**Service Bulletin:** SB EC145-624; Eurocopter EC145 Air Conditioner Aft Evaporator Condensation Prevention & Air Outlet Up-grade.

**Subject:** Up-grade of existing Eurocopter EC145 Air Conditioners equipped with the EC145-6028-2 Aft Evaporator Assembly, due to condensation issues in the main cabin overhead & air outlets.

**Date:** 10 May 2007, Rev N/C

**Applicability:** Eurocopter Helicopter model EC145 Equipped with the Air Comm Corporation EC145-200 Dual Forward Evaporator Air Conditioning System.

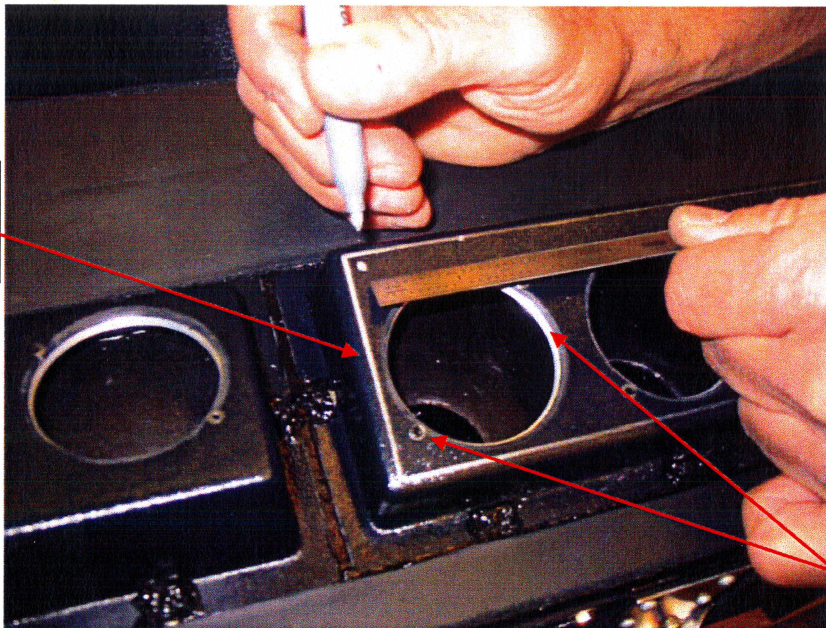
5. Remove the four (4) AN3-4A Bolts which hold the forward portion of the Aft Evaporator in place.

6. Remove the two (2) AN3-10A Bolts which hold the aft portion of the Aft Evaporator, and remove the evaporator from the aircraft.

Support the Aft Evaporator so that the expansion valve is protected from being damaged. Cap all exposed refrigerant lines to prevent contamination to the system.

**Figure 1-2**  
Continued

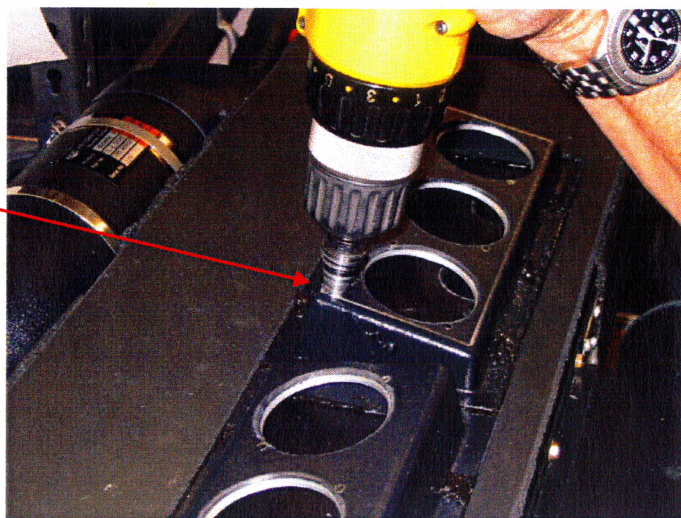
Scribe a line around the Plenum approximately as shown.

Remove rivets (2 Pls.) and threaded ring before attempting to cut the plastic portion of the Plenum Assembly.

Stop drill all four (4) corners of each of the two (2) Plenums before proceeding to the cutting stage of this modification.

**Figure 1-3**

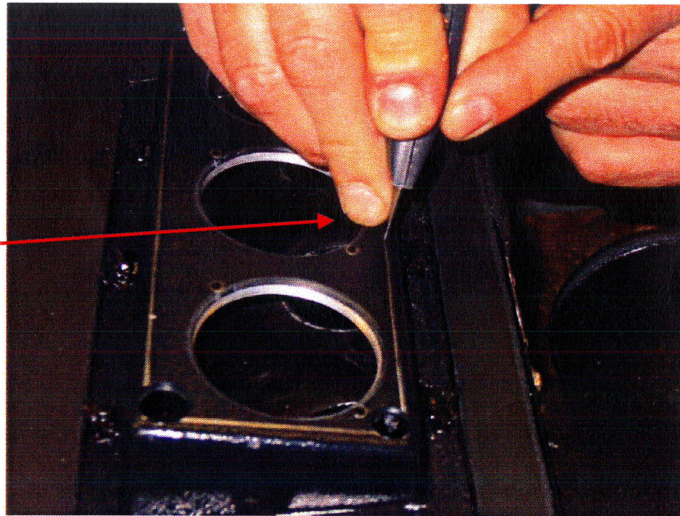
3. After stop drilling all of the corners as shown in Figure 1-2, use a razor knife or other suitable cutting devise to cut away the top surface of the Plenum, as shown in Figures 1-3 & 1-4.

Cut along the previously scribed or drawn lined using a razor knife or equivalent.

**Figure 1-4**

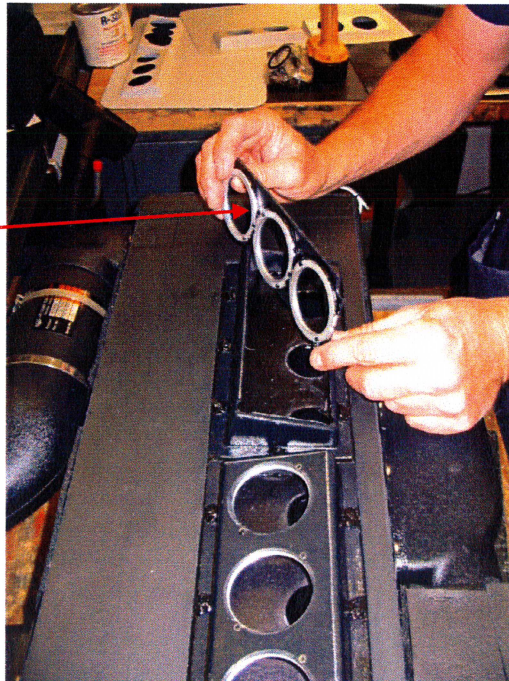
Remove and discard the top portion of the existing plenum assembly. (2 Pls.)

Figure 1-5

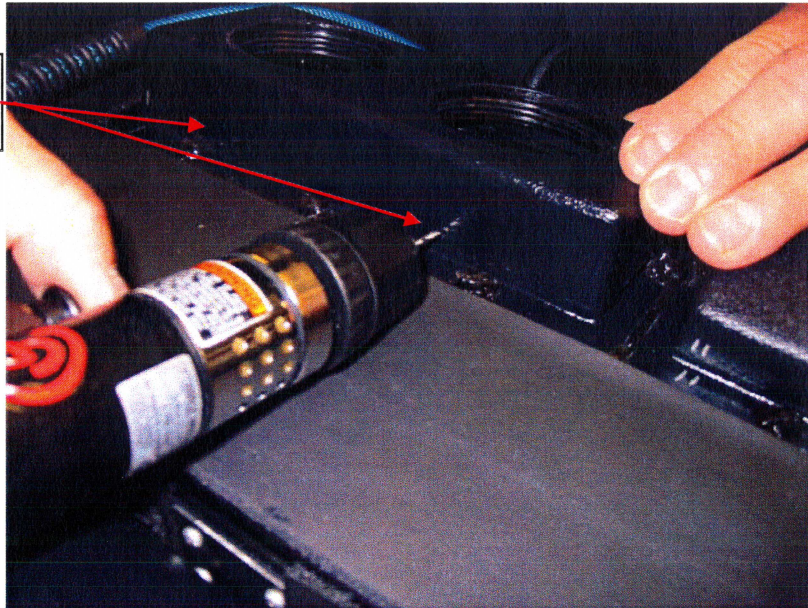
4. Install the two (2) new EC145-6012-2 Plenums on to the Aft Evaporator Assembly as shown in Figure 1-5, and match drill four (4) places, using a #40 drill bit on each Plenum.

Match drill using a #40 drill bit. (4Pls.)

Figure 1-6

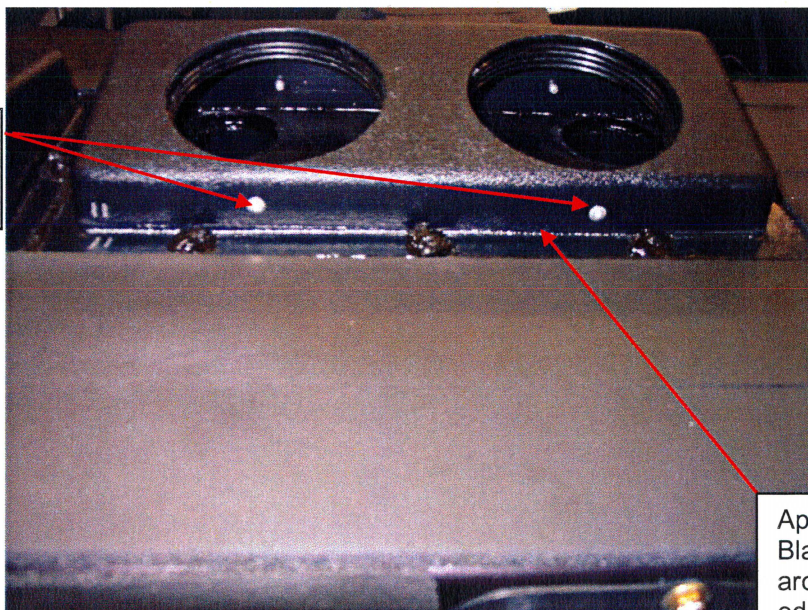
5. Install four (4) AA-32R Rivets to attach the new EC145-6012-2 Plenum to the Aft Evaporator Assembly, as shown in Figure 1-6.

Install AA-32R Rivets in the new plenum assembly. (4 Pls.)

Apply a thin bead of Black RTV sealant around the faying edges of the Plenum.

Figure 1-7

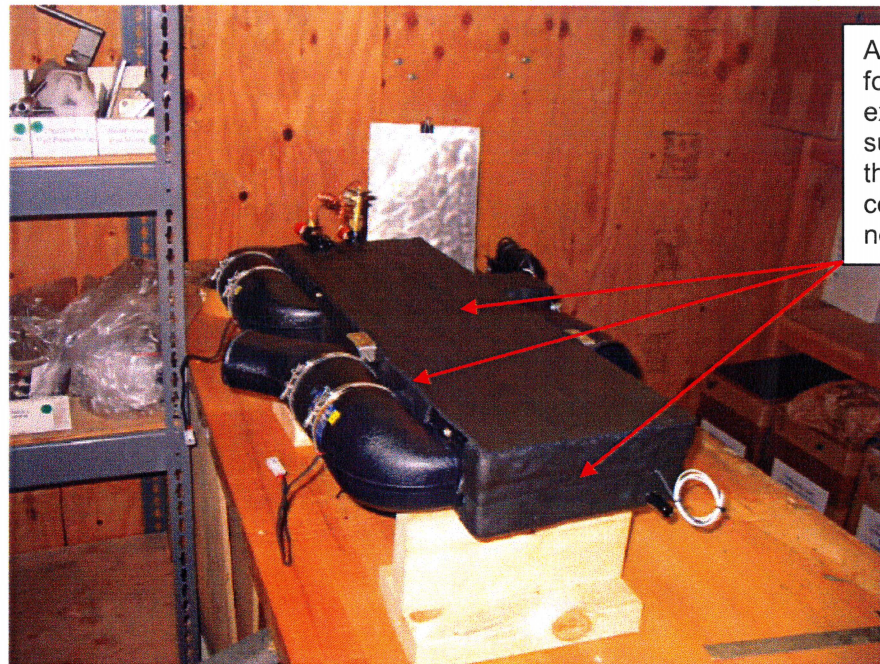
6. Apply a single layer of the ES06022-1 1/8" foam tape to all of the exposed metal surfaces of the Aft Evaporator Assembly as shown in Figure 1-7 & 1-8

Wipe all surfaces to which the foam tape is to be applied, with denatured alcohol (only) to insure a clean surface for the tape to adhere to.

Apply a single layer of foam tape to all of the exposed metal surfaces, to insulate these areas to prevent condensation as necessary.

Figure 1-8

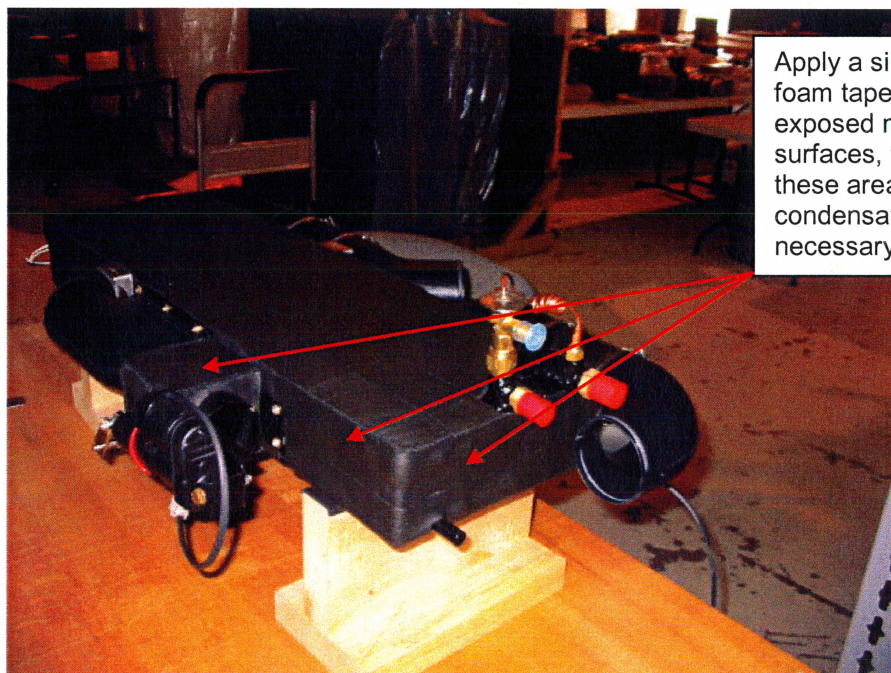
Apply a single layer of foam tape to all of the exposed metal surfaces, to insulate these areas to prevent condensation as necessary.
